GIRDER ~ G11T

SHOP DRAWING REVIEW
REVIEWED AS REQUIRED BY THE CONSTRUCTION CONTRACT DOCUMENTS AND APPROVED, BUT ONLY FOR CONFORMANCE TO THE DESIGN CONCEPT OF THE WORK AND GENERALLY TO THE HIGHWAY LIMITATIONS AND REQUIREMENTS CONTAINED IN THE CONSTRUCTION CONTRACT DOCUMENTS.
☐ FURNISH AS CORRECTED
☐ REVISE AND RESUBMIT
☐ REJECTED
CORRECTIONS OR COMMENTS MADE ON THIS SHOP DRAWING DURING THIS REVIEW DO NOT RELIEVE CONTRACTOR FROM COMPLIANCE WITH THE CONTRACT DRAWINGS AND SPECIFICATIONS. THIS CHECK OF THE PRINCIPLE DESIGN FEATURES ONLY AND DOES NOT INCLUDE REVIEW OF DIMENSIONS, QUANTITIES, FABRICATION PROCESSES AND TECHNIQUES OF CONSTRUCTION, COORDINATION OF THE WORK WITH THAT OF ALL OTHER TRADES, AND THE SATISFACTORY PERFORMANCE OF THE WORK UNDER THE CONTRACT.
VHB Vanasse Hangen Brustlin, Inc. Transportation, Land Development, Environmental Services
Six Bedford Farms Drive, Bedford, New Hampshire 03110 603-627-5500 www.vhb.com

GIRDER G11T
VT 78 OVER MISSISQUOI BAY, BRIDGE NO. 2
VT 78 STA.10+970.425 TO STA.12+059.775
TOWNS OF ALBURG AND SWANTON
COUNTIES OF GRAND ISLE AND FRANKLIN
STATE OF VERMONT, AGENCY OF TRANSPORTATION

STATE CONTRACT OR REF. NO. BRF-036-1(1)
CONTRACTOR CIANBRO CO

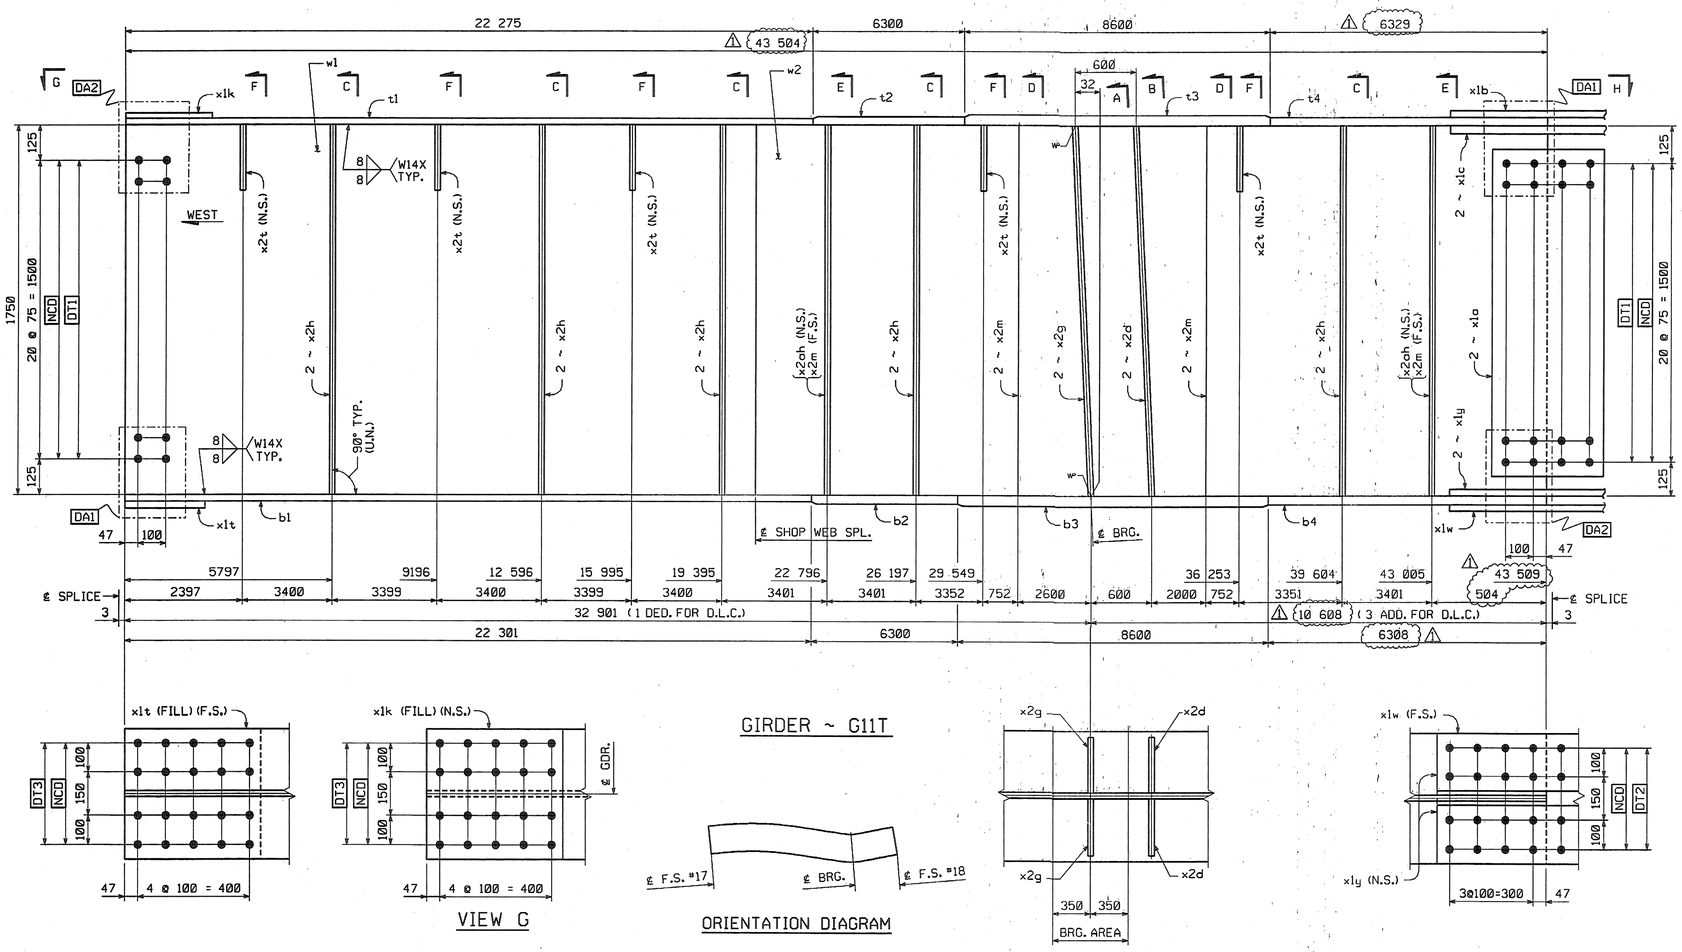
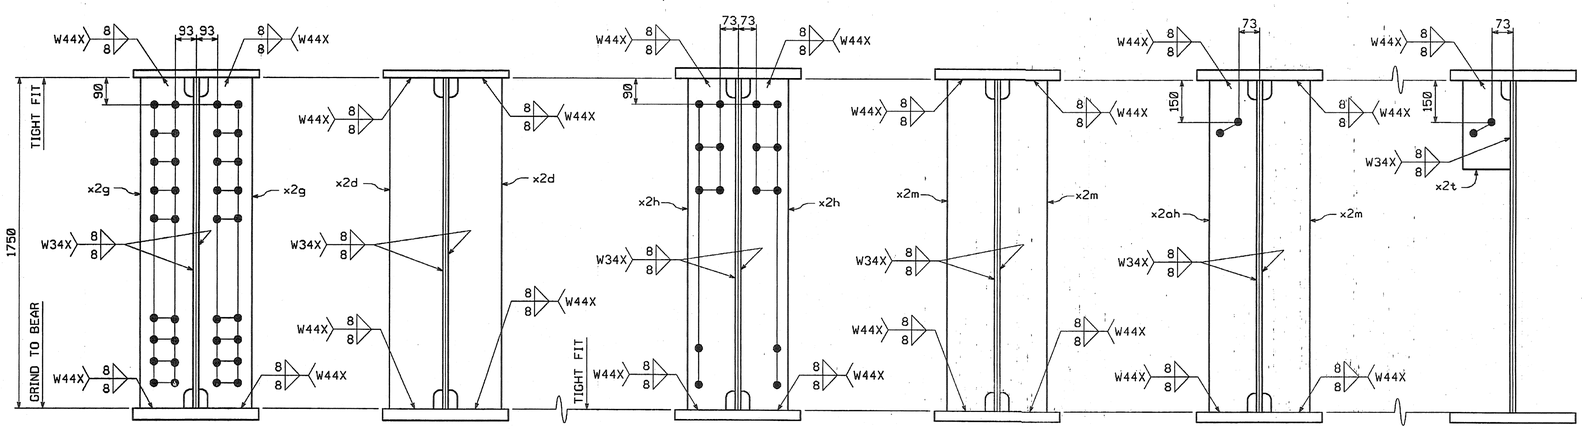
NO.	MARK	DESCRIPTION	LENGTH	REMARKS	GRP.	ITEM	SHIP. WT. KG. EA.
ONE	G11T	GIRDER					21 160
~~1~~	~~w1~~	~~PL 16 x 1750~~	~~19 908~~	~~(T)~~	~~3~~	~~9~~	~~4375.28~~
1	w2	PL 16 x 1750	~~23 608~~ 43506	(T)	3	2	~~5188.44~~ 9562.73
1	t1	PL 22 x 450	22 275	(T)	4	25	~~1730.90~~ 1731.10
1	t2	PL 32 x 450	6 300	(T)	4	15	~~712.07~~ 712.15
1	t3	PL 65 x 450	8 600	(T)	4	3	~~1974.44~~ 1974.67
1	t4	PL 32 x 450	6 329	(T)	4	13	~~715.35~~ 715.43
1	b1	PL 22 x 450	22 301	(T)	4	23	1732.92 1733.12
1	b2	PL 32 x 450	6 300	(T)	4	15	712.07 712.15
1	b3	PL 65 x 450	8 600	(T)	4	3	~~1974.44~~ 1974.67
1	b4	PL 32 x 450	6 308	(T)	4	14	~~712.97~~ 713.06
2	x1a	PL 12 x 1600	400	(T)	6	1	~~60.28~~ 120.58
1	x1b	PL 14 x 450	790	(T)	6	6	~~39.06~~ 39.07
2	x1c	PL 16 x 200	790	(T)	6	5	~~19.84~~ 39.69
1	x1k	PL 18 x 450	492	FILL	6	4	31.28
1	x1t	PL 18 x 450	492	FILL	6	4	31.28
1	x1w	PL 14 x 450	790	(T)	6	6	~~39.06~~ 39.07
2	x1y	PL 16 x 200	790	(T)	6	5	~~19.84~~ 39.69

2	x2d	PL 38 x 200	1 750		7	1	~~104.39~~ 208.81
2	x2g	PL 38 x 200	1 750		7	1	~~104.39~~ 208.81
10	x2h	PL 12 x 180	1 750		7	4	~~29.67~~ 296.73
6	x2m	PL 12 x 180	1 750		7	4	~~29.67~~ 178.04
5	x2t	PL 14 x 180	310		7	3	~~6.13~~ 30.66
2	x2ah	PL 12 x 180	1 750		7	4	~~29.67~~ 59.35

TOTAL WEIGHT THIS SHEET: ~~21 151.8~~ 21152.14 kgs

NO.	REVISION	BY	DATE
1	INCREASE LENGTHS TO SATISFY REQUIREMENTS FOR LENGTH @ MEAN TEMPERATURE OF 45°F.	DP	9/20/04
